Product Change Notification

Model PM3602 - Change to Pitch on Tape and Quantity per Reel

Revised Pitch Dimension

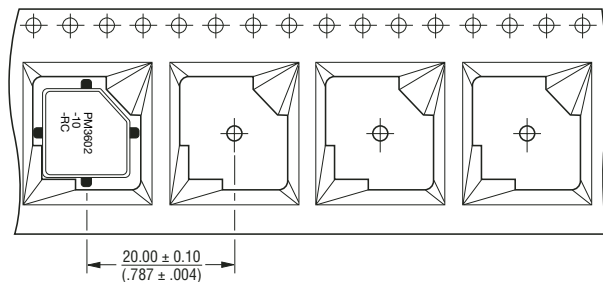
The distance between the center of the parts on the tape (pitch) of [Model PM3602](#), an inductor/transformer, will change to 20 mm beginning with date code 0909. Currently, the pitch is 16 mm between components on the tape-and-reel packaging. As a result of the greater pitch dimension, the quantity per reel will be reduced to 400 pieces per 13-inch reel (from the current 700 pieces per 13-inch reel).
